K200826-6a

GEOTECHNICAL RFI LETTER

PLAN CHANGE 120 - 2127 KAIPARA COAST HIGHWAY, MAKARAU

Figure 1: Shallow Landslide Susceptibility Map (North Up Page)

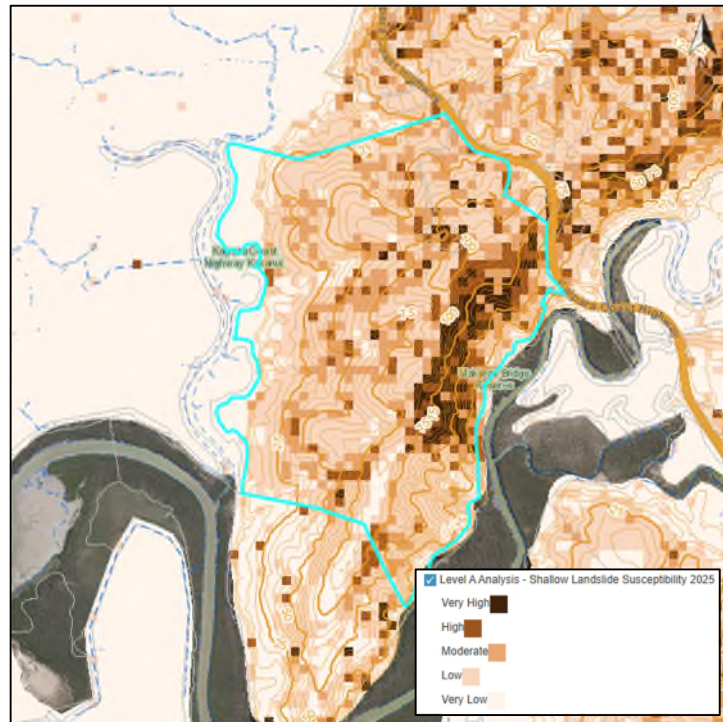
The subject site comprises 2127 Kaipara Coast Highway, Kakanui 0984, and is legally described as Pt Sec 50 Blk II Kaipara Survey District SO 51097, Sec 1 SO 328127, Pt Makarau Blk 4A SO 28095, Pt Makaray Blk 4B SO 28095. The site has an approximate plan area of 133.9Ha. We have assessed the AC GeoMaps portal to check for mapped susceptibility for both the shallow and deep-seated landslides. For the benefit of this assessment, we have chosen the highest susceptibility risk mapped feature within the four properties for our assessment of shallow instability. For large scale landslides, we are required to assess the highest risk mapped susceptibility at the site and within a 150m runout zone.

These maps indicate that the land within these properties is classified as medium to very high susceptibility for both shallow and large-scale landslides.

Figure 3: Example of Cross-Section N–N’ showing offset from raised-groundwater failure surfaces (FoS < 1.3).

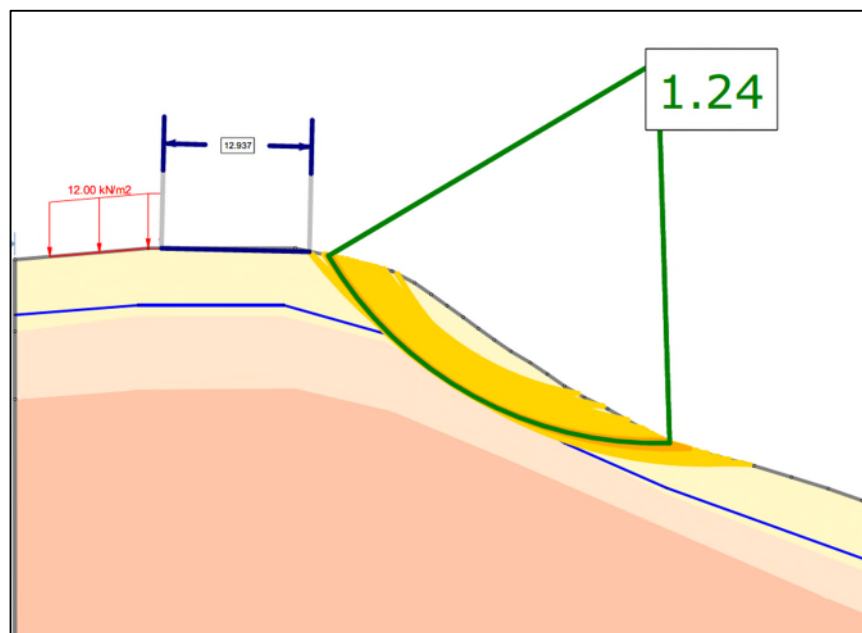
The only exception was Cross-Section N–N’, representing a portion of the accessway located near the crest of the steeper eastern slopes. This analysis returned FoS values below Auckland Council criteria (though all FoS > 1.0), consistent with the shallow movement observed during the 2023 walkover. In response, the proposed accessway alignment was shifted further west, set back from the slope crest. Updated analyses demonstrate compliant FoS along the revised alignment.
